NUCLEAR REACTOR LABORATORY
AN INTERDEPARTMENTAL CENTER OF
MASSACHUSETTS INSTITUTE OF TECHNOLOGY

Subject: Response to TAC No. MB3761, License No. R-37, Docket No. 50-20.

Response to NRC request for additional information 9/5/02

Figure 9-2

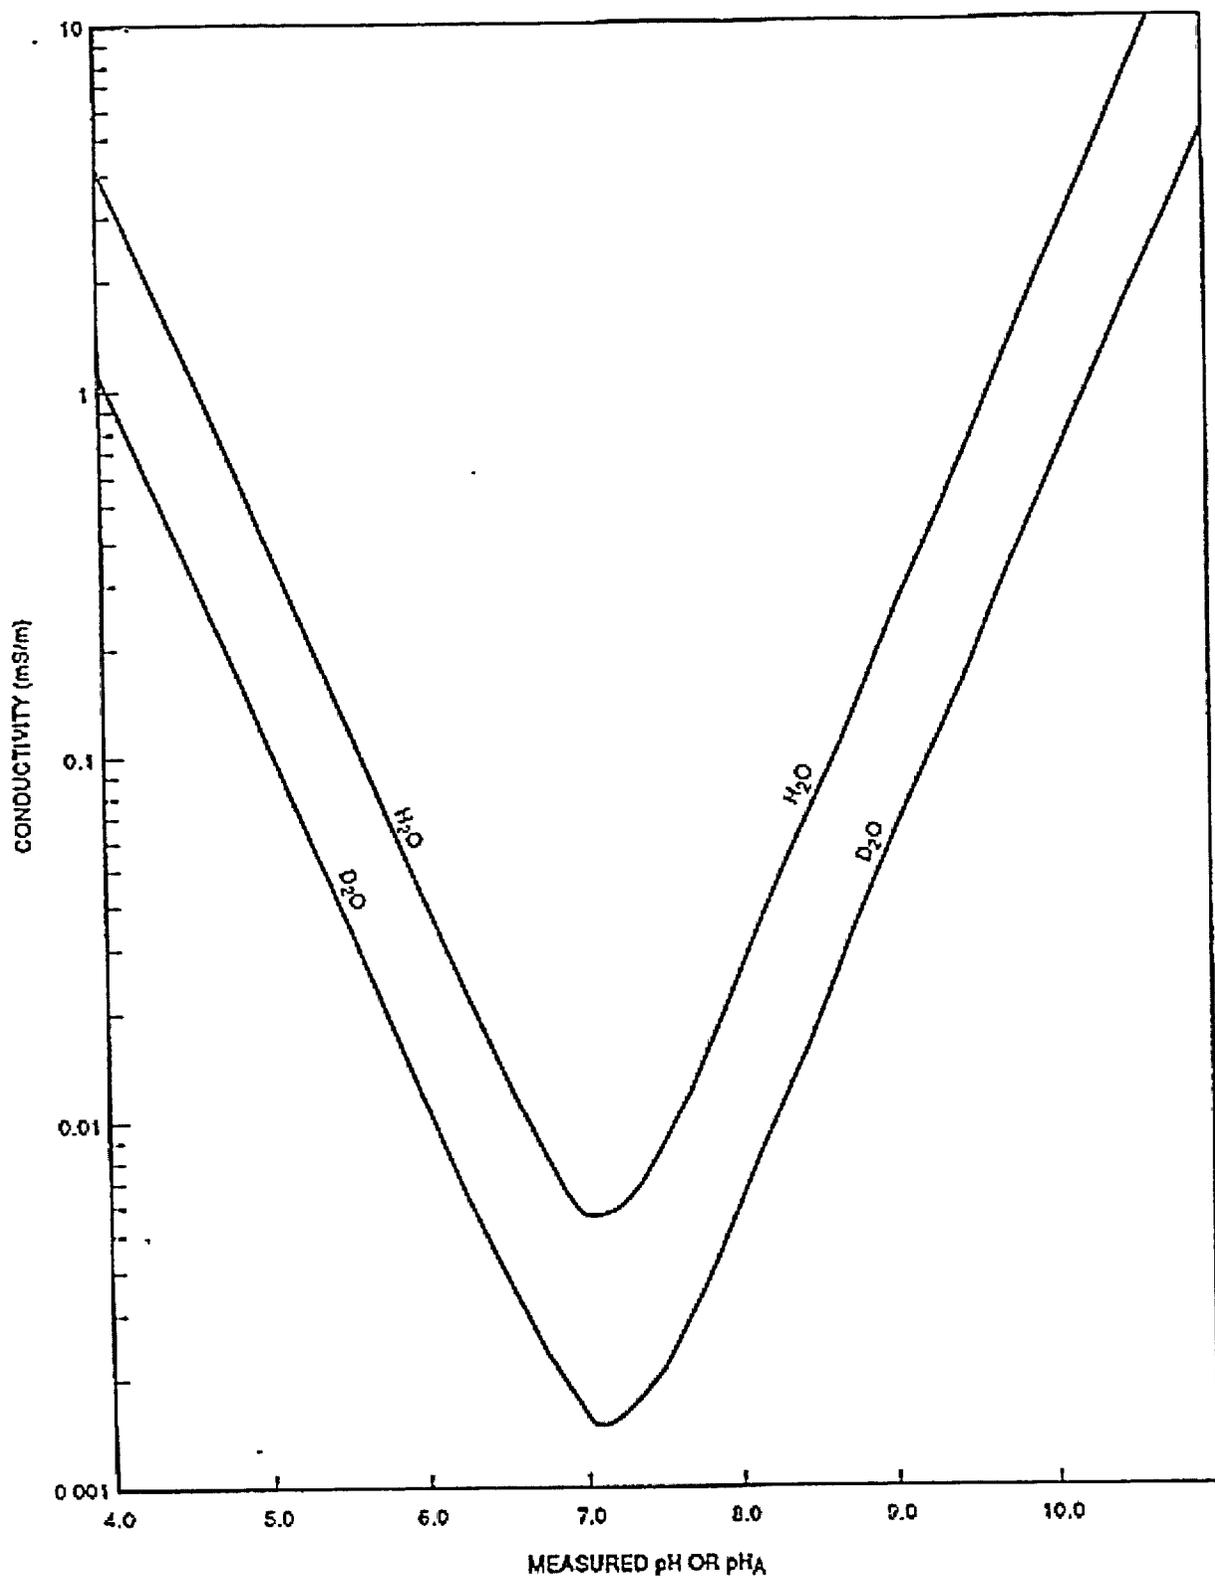
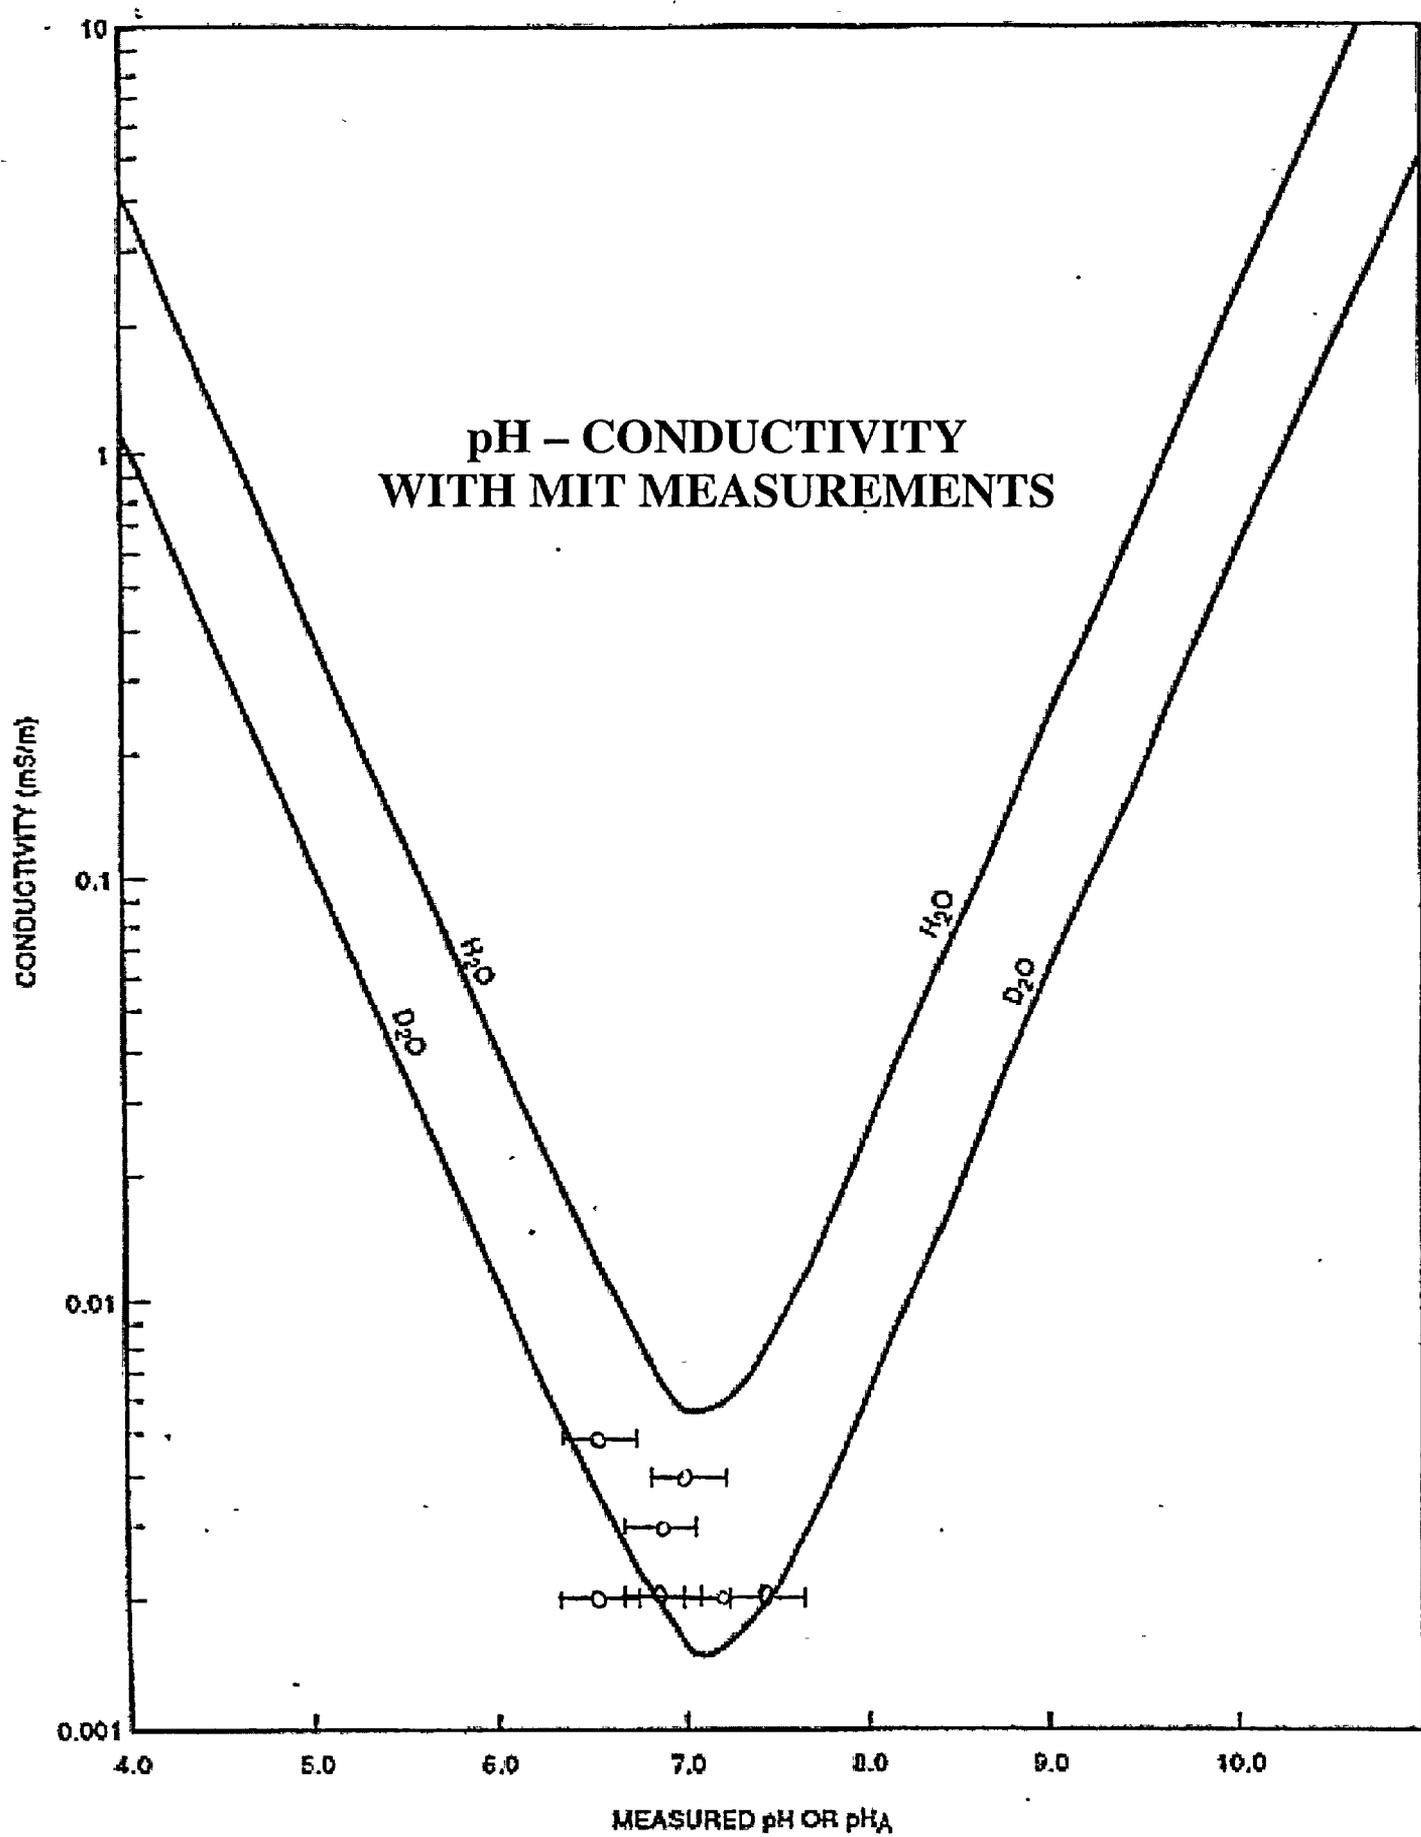
5. Units in TS 6.6.2.6 have been changed to $\mu\text{S}/\text{cm}$.
6. Attached is a graph of H_2O and D_2O conductivity vs. pH from D. Barber and J.P. Van Berlo, "An Introduction to CANDU Chemistry," AECL CANDU, March 1994. It shows both H_2O and D_2O have similar shapes, with the D_2O conductivity slightly lower. Measurements of pH are made monthly. The data are close (i.e., within measurement error) to the calculated pH-conductivity curve for D_2O .
